SERVICE DIRECTIVE BULLETIN NO. T-030

1. SUBJECT: Inspection of Circuit Breaker Bus Bar Installation
2. MODEL: 480B
3. EFFECTIVITY: Serial numbers 5083 through 5107
4. BACKGROUND:

Figure 2. Circuit Breaker Bus Bar Installation

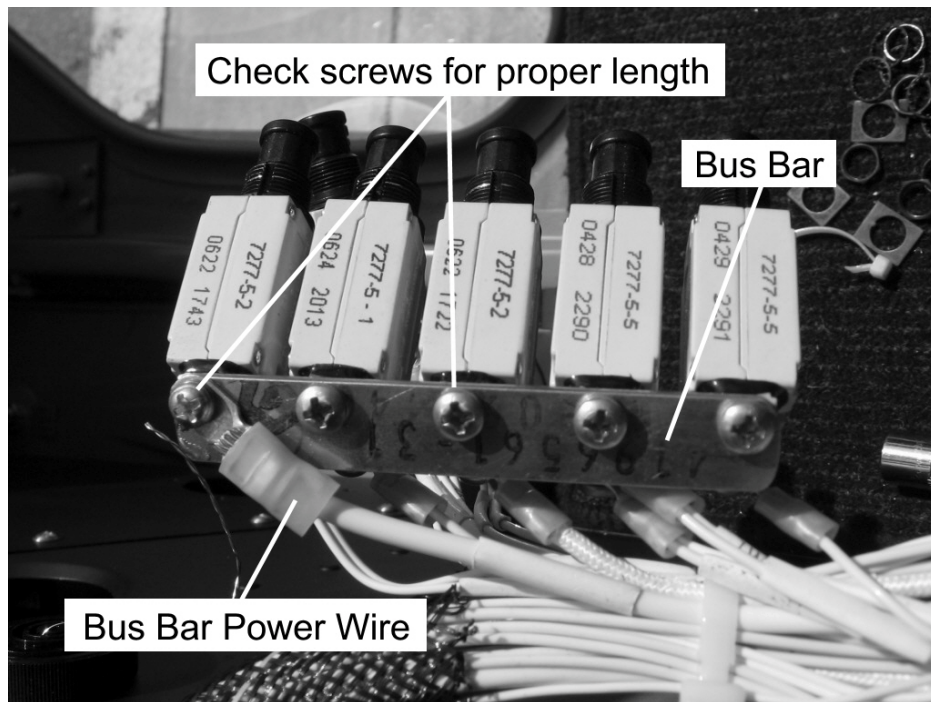
- E. Remove the four (4) mounting screws from the switch panel assembly and remove the switch panel from the pedestal.
- F. Inspect the circuit breaker bus bar and bus bar power wire installations for proper length screws (See Figure 2). They should have a minimum of 1½ to 2 threads protruding from the breaker mounting tab. If the screws are too short, remove the screws and replace with the proper length screws IAW paragraph 5.2.

The “standard” screws, mentioned in paragraph 4, provided with the circuit breakers are slotted/flat tip type screws. If the standard screws are installed in the bus bars and bus bar power wires, they are too short.

- A. Remove screws that are too short from the bus bar and/or bus bar power wire installations and install proper length screws as required. Refer to paragraph 5.3 for the part numbers of the proper length screws. The lock washers can be reused depending on their condition; replace the lock washers as necessary.

Figure 3. Switch Panel Bus Bar Installation

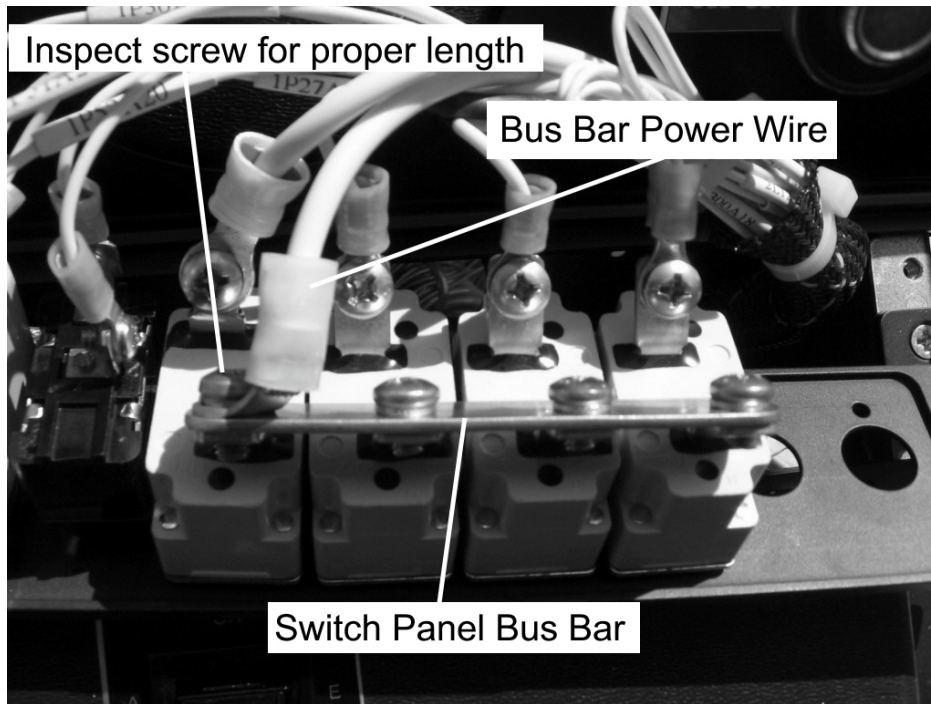
- G. Inspect the bus bar power wire installation on the switch panel assembly (See Figure 3). There should be 1½ to 2 threads protruding from the switch/breaker mounting tab. If the screw is too short, remove the screw and replace with the proper length screw IAW paragraph 5.2.
- E. If the bus bars and bus bar power wires are installed correctly, reinstall the circuit breaker segments; switch panel assembly; illuminated panel; and trim panels, and return the aircraft to service.
